Subject: Renewal of Special Nuclear Materials License
SNM-777, Docket 70-820 Regulatory File Cy.

RESPONSE TO AEC COMMENTS ON RENEWAL OF SPECIAL
NUCLEAR MATERIAL LICENSE SNM-777, DOCKET 70-820

Subject: Renewal of Special Nuclear Material License SNM-777

Figure 309-XXIV

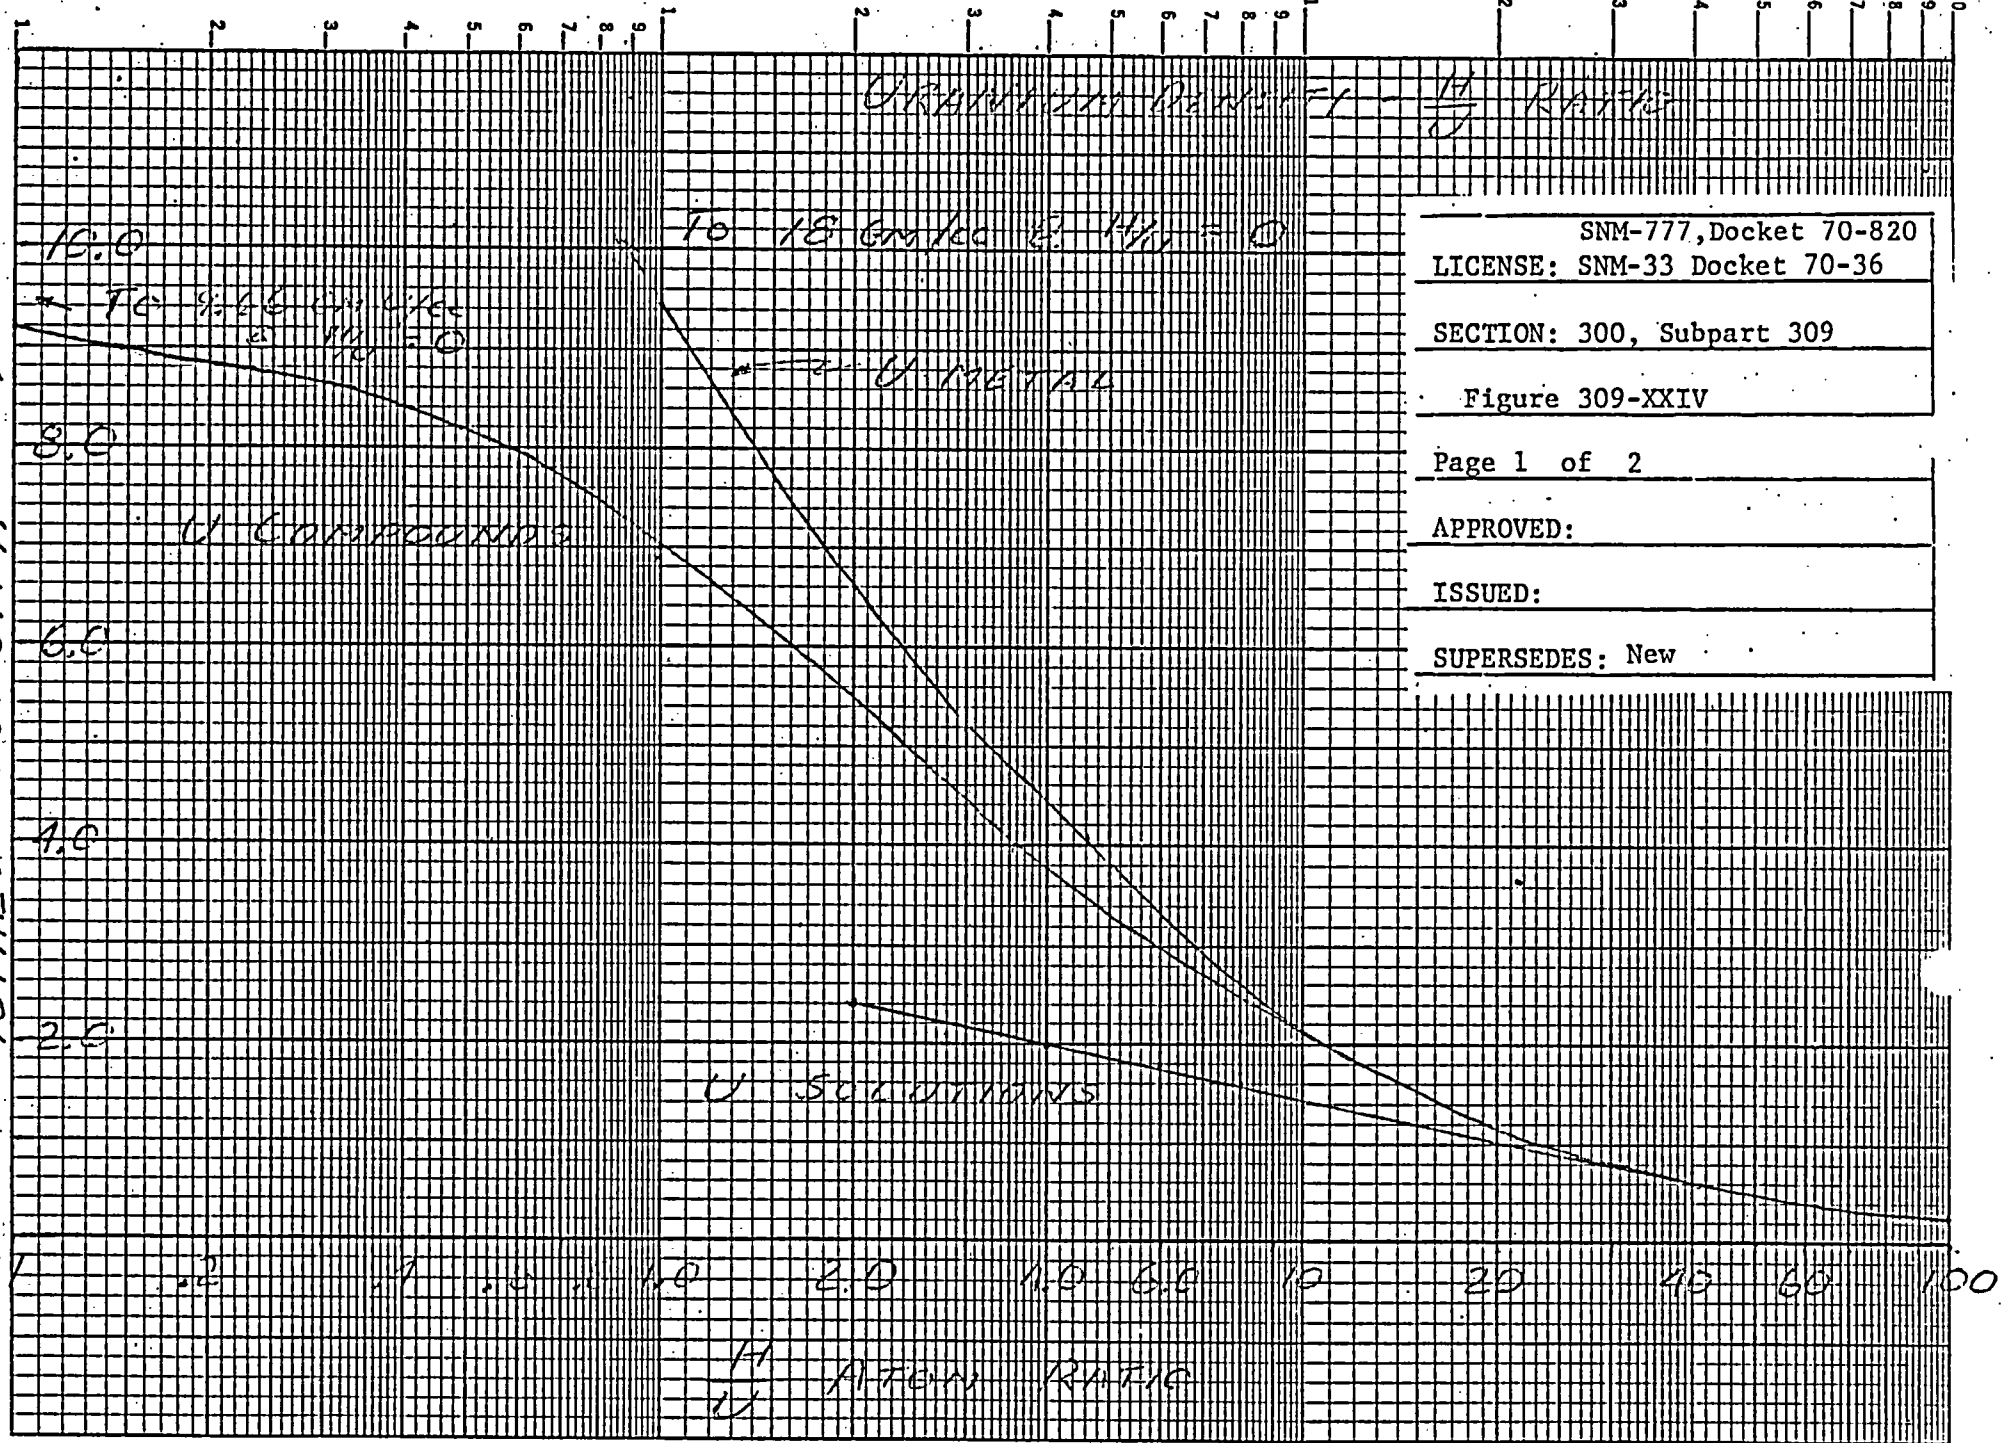
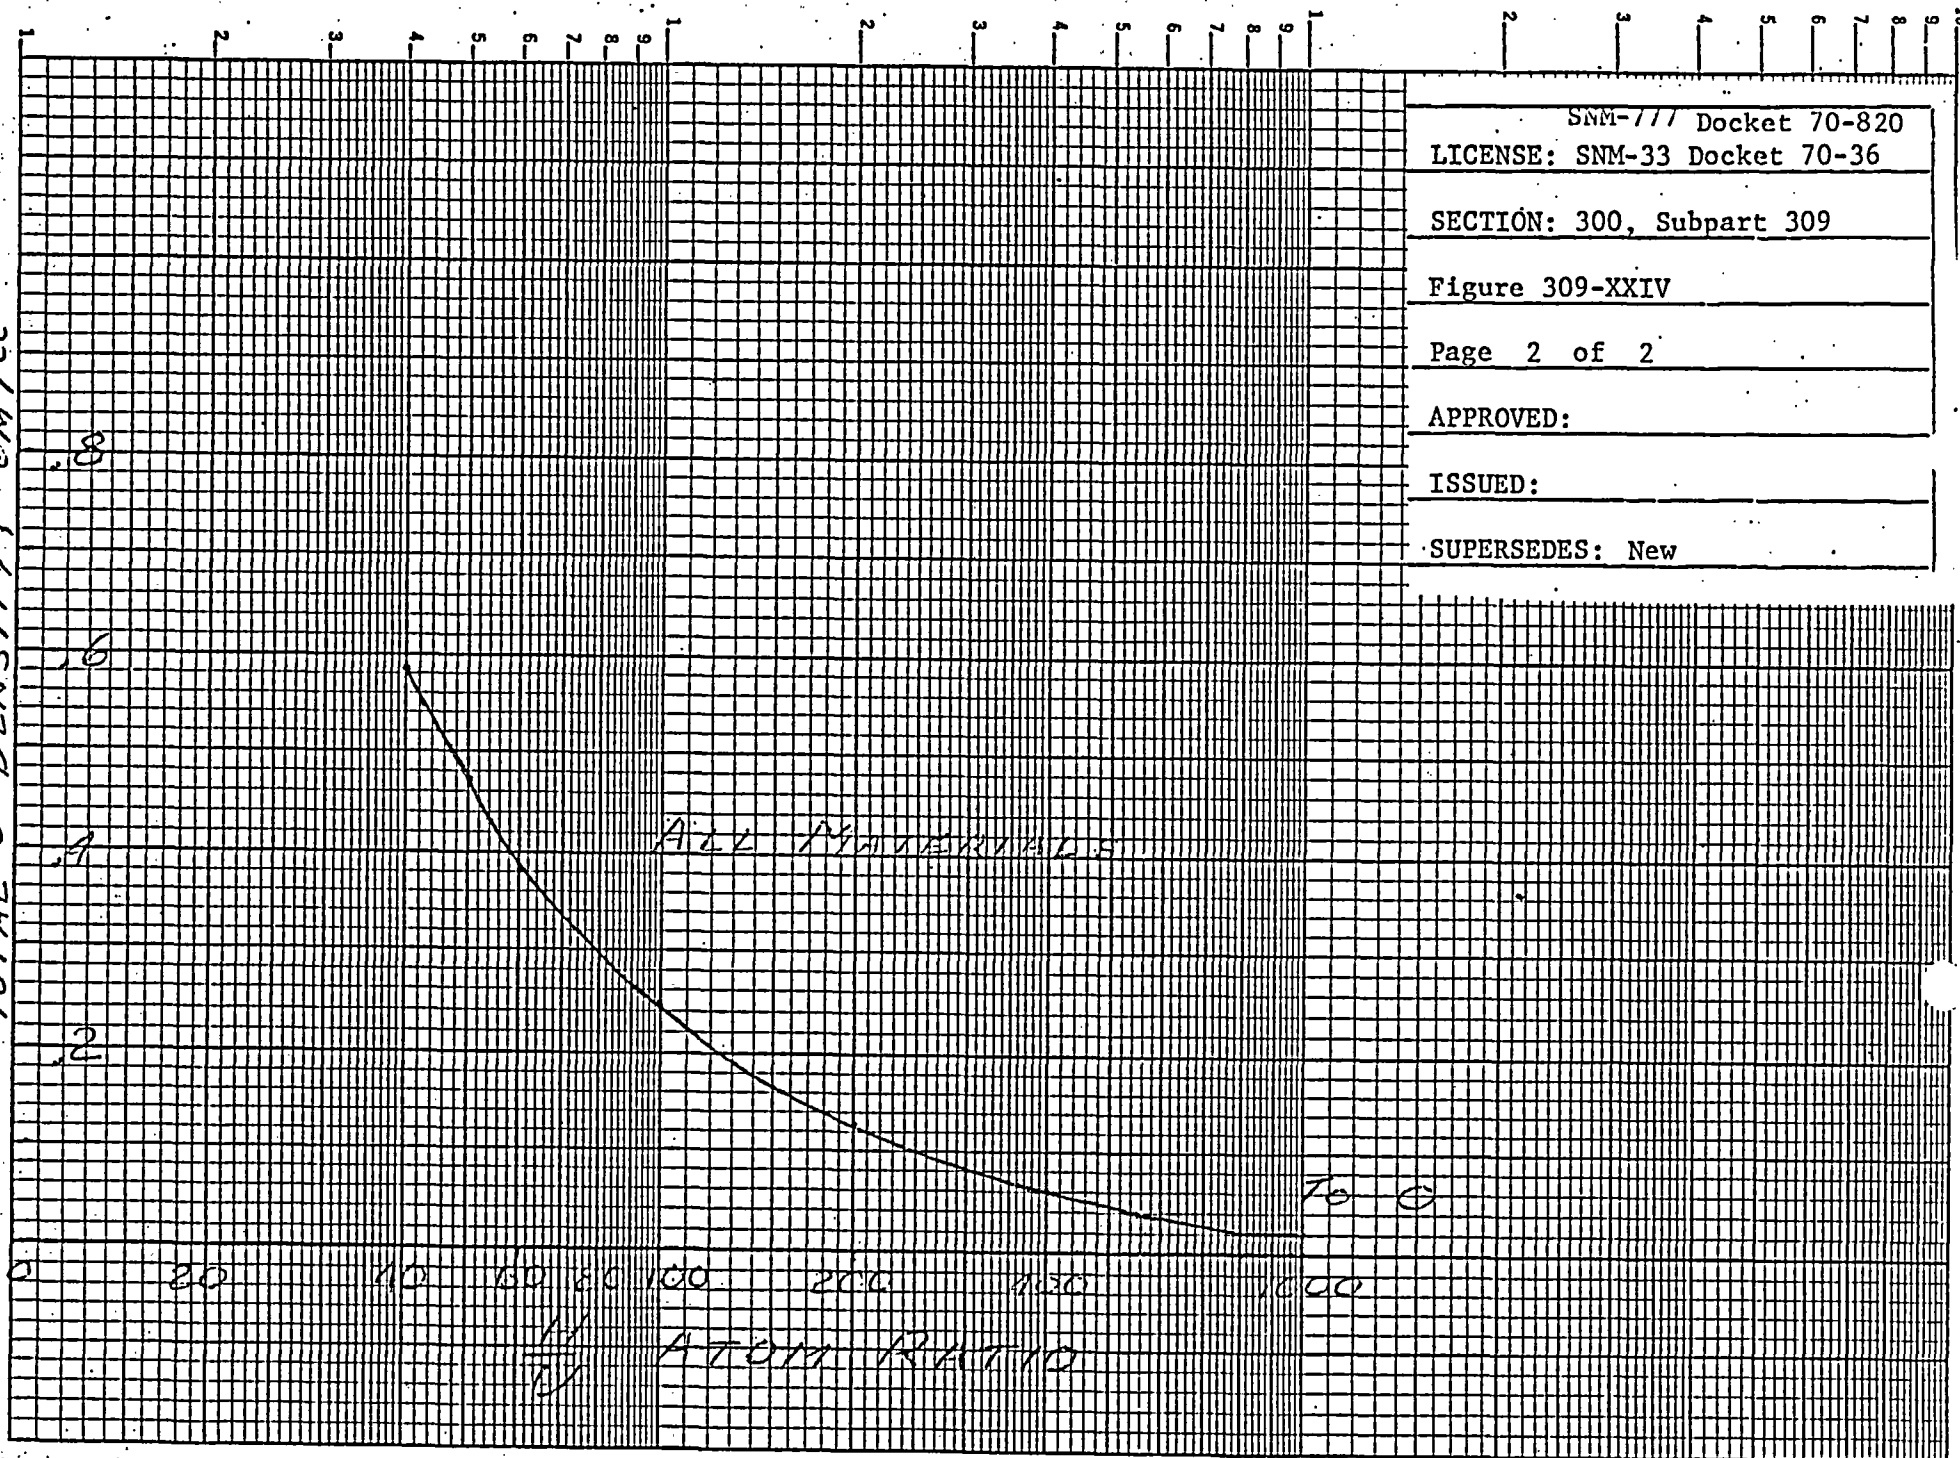
Comment: How is the actual material density known?

Replace Tables 309-I and 309-II with attached revised tables and associated Nuclear Safety Evaluations. Add Figures 309-XXIV through 309-XXVIII and their associated Nuclear Safety Evaluations.

These are included to reflect AEC comment on density/moderator relationship.

Answer: Uranium solutions processed within the scope of this license have uranium concentrations no greater than that of UO_2F_2 .

Uranium compounds processed within the scope of this license have bulk densities not greater than that of UO_2 powder which has a bulk density not more than 4 grams U/cc. Refer to Figure 309-XXIV.
